Model: Model K-P3		Date: 14-Nov-03	No.: RG091001
Subject: Service Manual Correction		Prepared by: A. Ishiyama	
From: 1st Technical Support sec. Service Support Dept.			
Classification:	<input type="checkbox"/> Troubleshooting	<input type="checkbox"/> Part information	<input type="checkbox"/> Action required
	<input type="checkbox"/> Mechanical	<input type="checkbox"/> Electrical	<input checked="" type="checkbox"/> Service manual revision
	<input type="checkbox"/> Paper path	<input type="checkbox"/> Transmit/receive	<input type="checkbox"/> Retrofit information
	<input type="checkbox"/> Other (      )

Model: Model K-P3		Date: 26-Apr-04	No.: RG091003
Subject: Engine Board		Prepared by: A. Ishiyama	
From: 1st Technical Support Sec. Service Support Dept.			
Classification:	<input type="checkbox"/> Troubleshooting	<input type="checkbox"/> Part information	<input checked="" type="checkbox"/> Action required
	<input type="checkbox"/> Mechanical	<input type="checkbox"/> Electrical	<input type="checkbox"/> Service manual revision
	<input type="checkbox"/> Paper path	<input type="checkbox"/> Transmit/receive	<input type="checkbox"/> Retrofit information
	<input type="checkbox"/> Other ( )

**Minor Modification of old G0885123 Engine Board to its New Version**

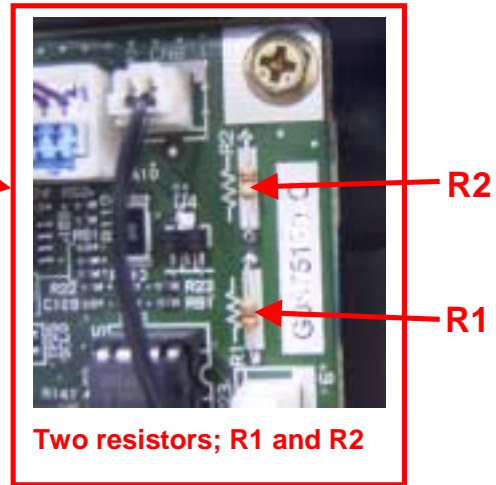
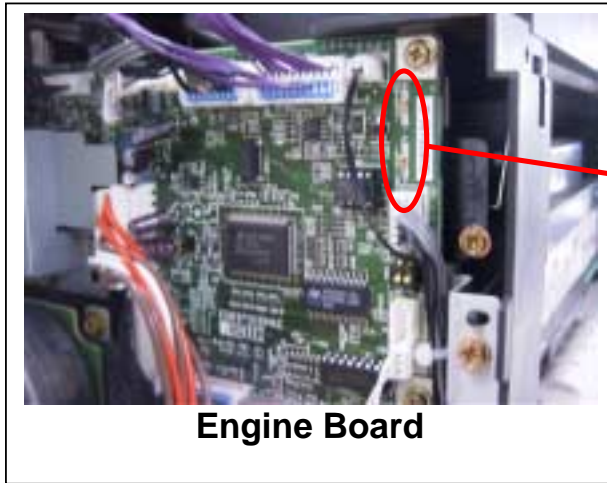
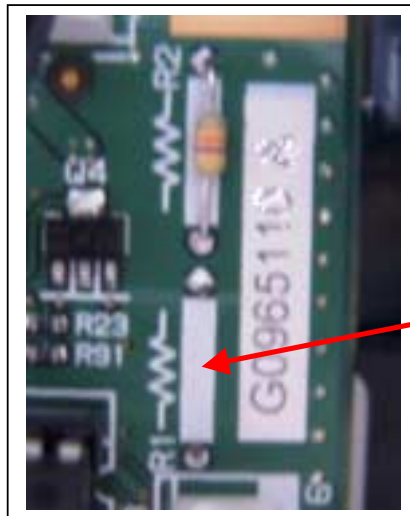
The old engine board (G0885123) contains two resistors, R1 and R2, but the new board for NA (G0885121) contains only R2 and the new board for EU/Asia (G0885122) contains only R1.

2. **For NA version**  
 Remove R1 as shown below using a pair of wire cutters (nippers).

**Remove R1 using a pair of wire cutters**

**For EU/Asia version**

In the same manner, **remove R2 using a pair of wire cutters.**
